Intel® Mobile Celeron™ Processor Specification Update

Release Date: July 1999

Order Number: 244444-006

The Intel® Mobile Celeron™ processor or the Intel® Celeron™ Processor Mobile Module may contain design defects or errors known as errata which may cause the product to deviate from published specifications. Current characterized errata are documented in this Specification Update.

Figure 2. Workaround Flowchart: SMBALERT#-Driven System

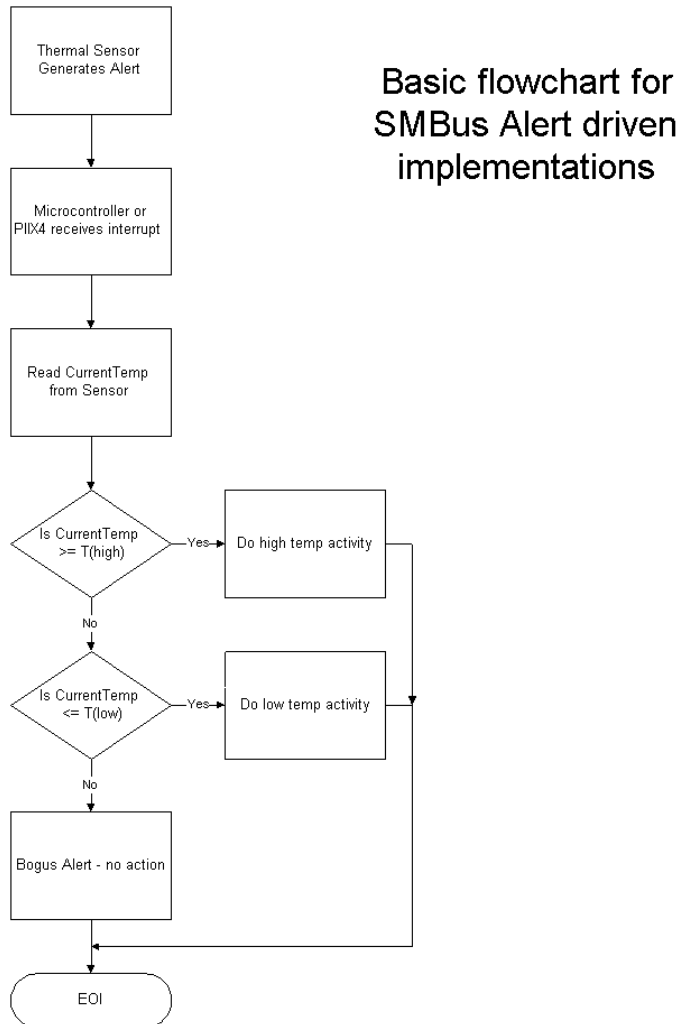
WORKAROUND: Three different (mutually exclusive) workarounds are possible:

1. Before servicing an interrupt from the thermal sensor, read and compare the processor thermal reading with the threshold limits (T_{HIGH} or T_{LOW}). Figures 2 and 3 provide basic flowcharts for the implementation of this workaround in an interrupt driven system.
2. If the firmware implemented polls the Status Register only, then before taking any action, re-read the temperature register and do a comparison with the alarm threshold limits (T_{HIGH} or T_{LOW}) to determine if the value is actually still within the temperature window.
3. Use a temperature polling scheme to monitor the processor temperature.

Figure 5.3. Surface-Mount BGA1 Package—Top and Side View

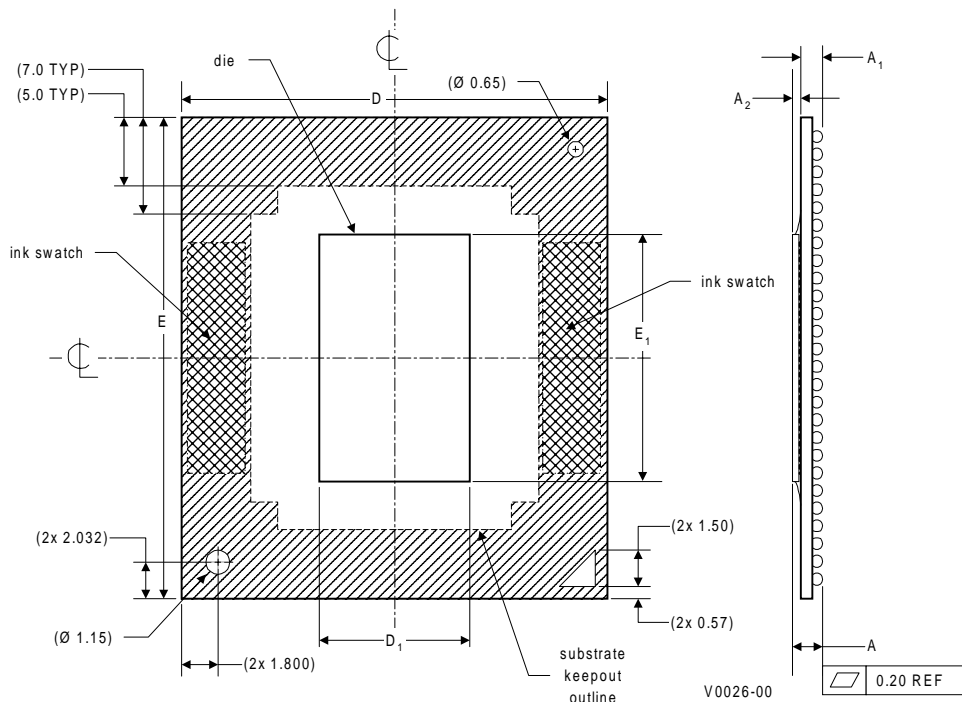
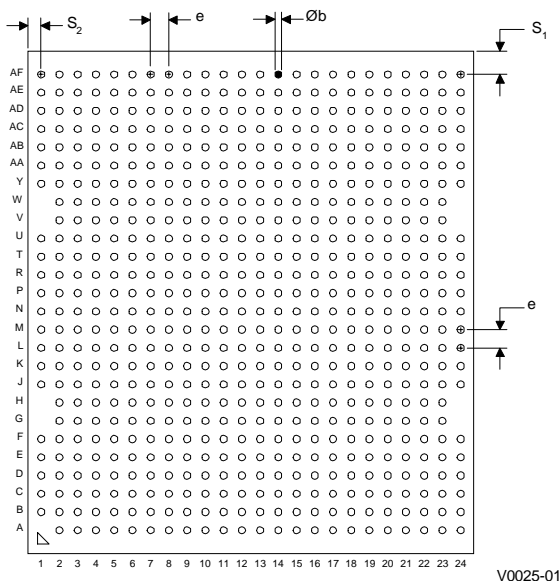
The following table and figures show the updated mechanical specifications for the BGA1 package, listed as Table 5.2, Figure 5.3 and 5.4, respectively, in the *Intel® Mobile Celeron™ Processor in BGA Package at 333 MHz, 300 MHz and 266 MHz* datasheet.

1. The number shown here is different from that in last month's specification update. The maximum reference number is used.

Figure 3.3 Generic Clock Waveform

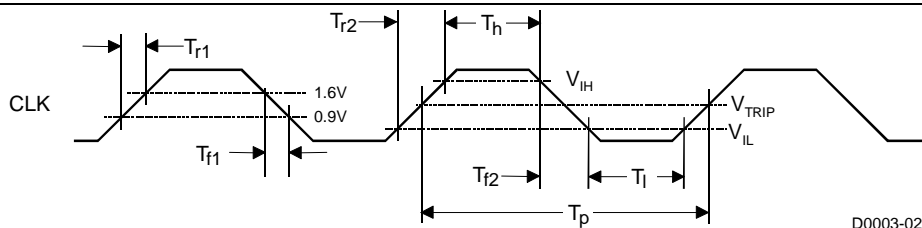
H11. Generic Clock Waveform Figure

Figure 3.3 in the *Intel® Mobile Celeron™ Processor in μ PGA1 and BGA1 Packages at 366 MHz, 333 MHz, 300 MHz, and 266 MHz* datasheet (Order Number 245112-003) has been updated. The following figure is to replace the one in the above document.
